SERVICE BULLETIN

M-1207

Safety Recall Code 0130

2007 SOFTAIL BATTERY CABLE ROUTING RECALL

Figure 1. Battery Cable Orientation

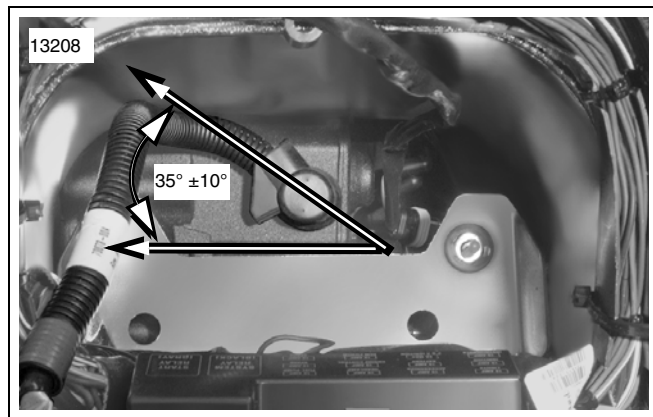
4. See Figure 1. Reposition positive battery cable routing at starter. Cable must face 35° forward from left side of vehicle $\pm 10^{\circ}$.
5. Loosen starter nut and adjust positive cable to proper orientation. Tighten starter nut to 70-90 in-lbs (7.9-10.2 Nm).

Figure 2. Battery Caddy

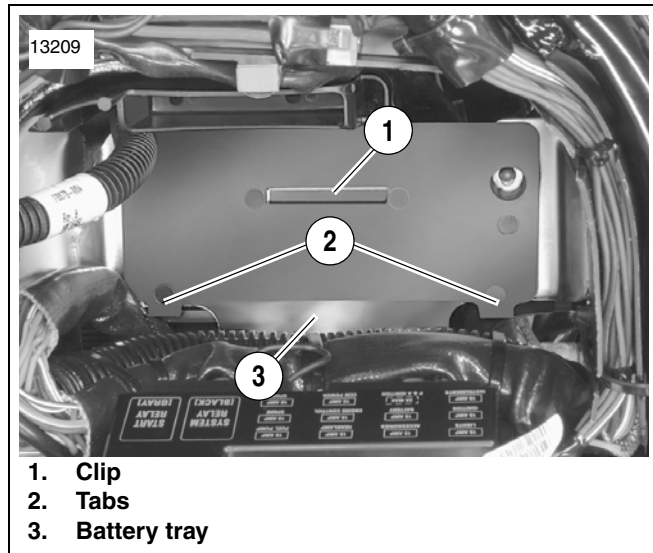
6. See Figure 2. Clip battery caddy to front of battery tray. Be sure tabs (2) of caddy fit over rear of battery tray (3).
7. See Figure 3. Install positive battery cable (1) into clip in caddy. Be sure S-shaped bend (3) in cable is present and cable conduit (2) is positioned adjacent to terminal as shown.

Figure 3. Battery Caddy Wiring

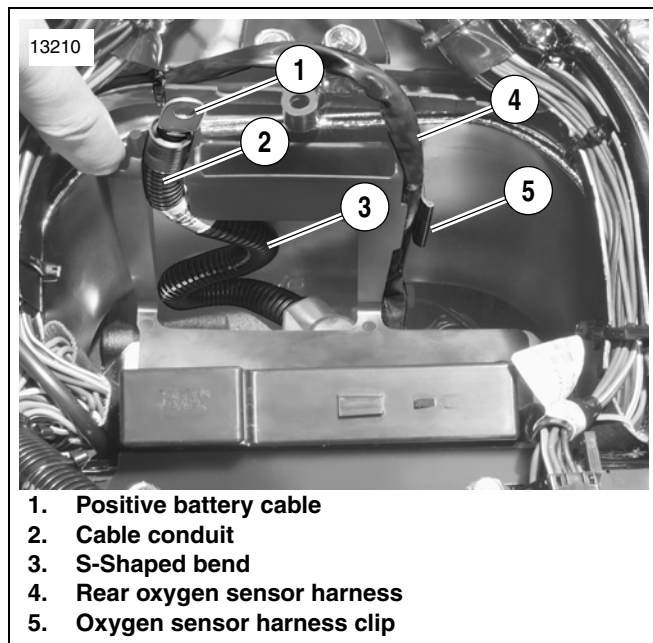
8. Route rear oxygen sensor harness (4) through clip (5).
